SUBJECT: **CUP-6-19/SP-2-19 Conditional Use Permit and Site Plan Approval for a Commercial Shopping Center on Lot X-2 of the Edith Morgan Tract.**

CUP-6-19/SP-2-19 Central City Commercial Center

Development Review Committee (DRC) Comments

Title: LANDSCAPE PLANTING PLAN

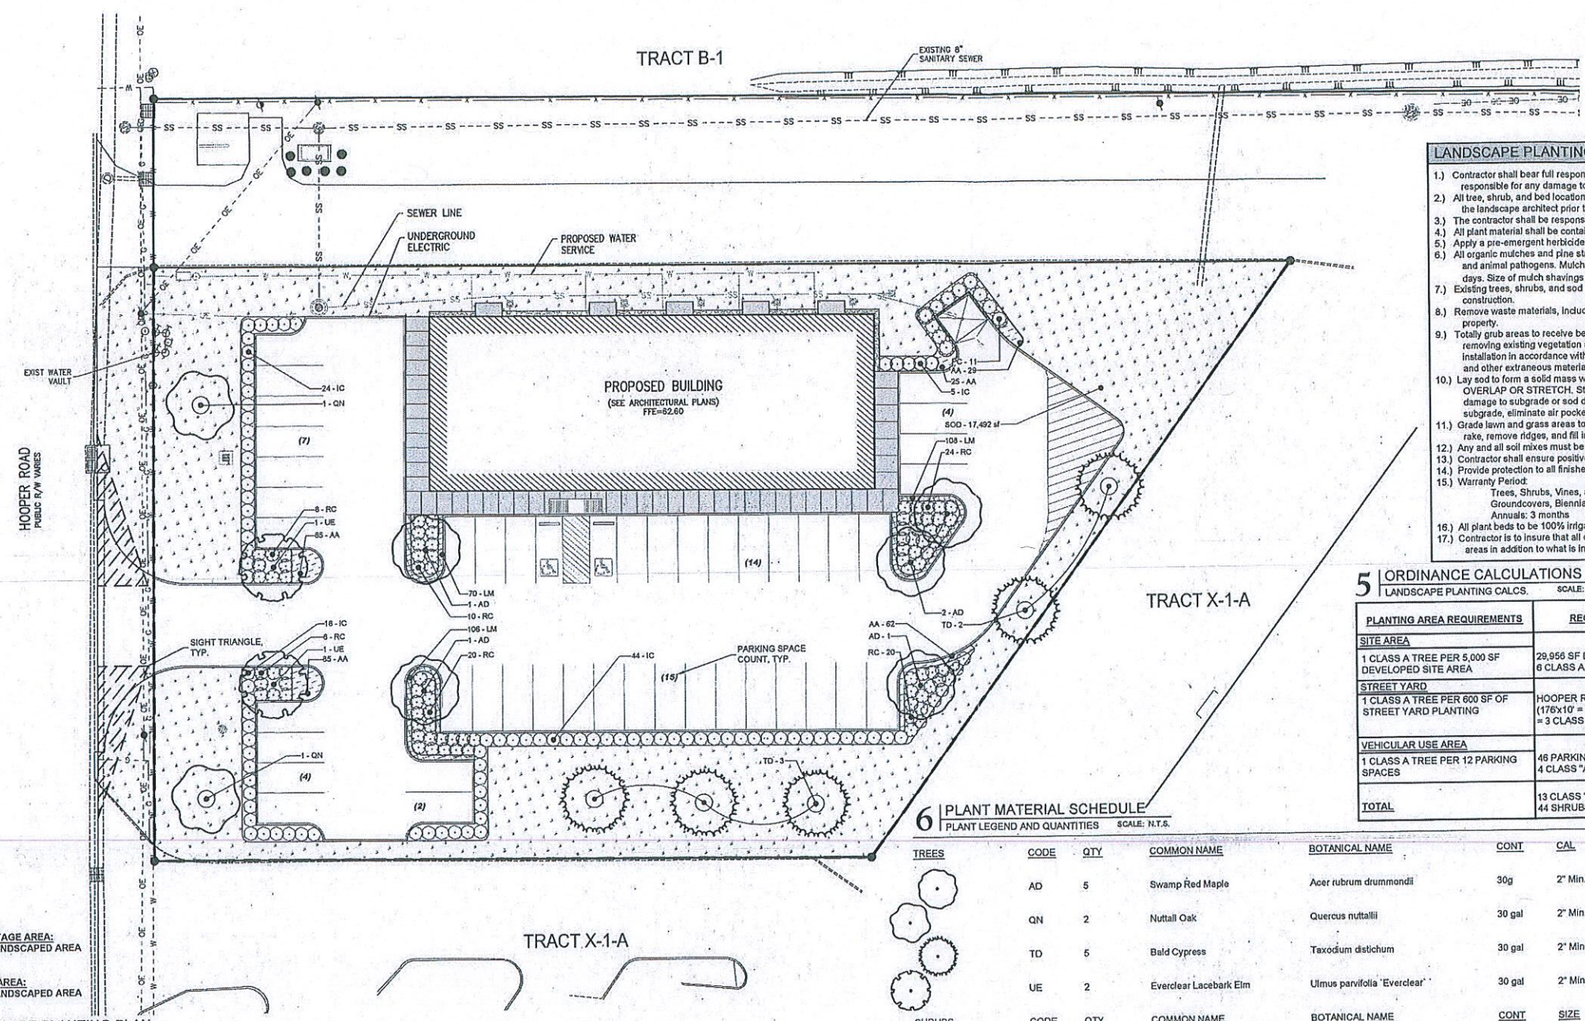
1. Staff highly encourages inter-parcel connectivity, but understands that the adjacent landowner is unwilling to provide such access.
2. Larger shrubs or a berm should be added to adequately screen the parking in front of the development along Hooper Road.
3. Utility areas to the rear of the building shall be screened in accordance with the Development Code.

1.) All plant material to screen parking shall be three feet (3') high at time of planting.
2.) To achieve the 3' height at time of planting, landscape contractor can provide a 1' high planting bed berm and 2' high shrubs in lieu of 3' high plant materials.
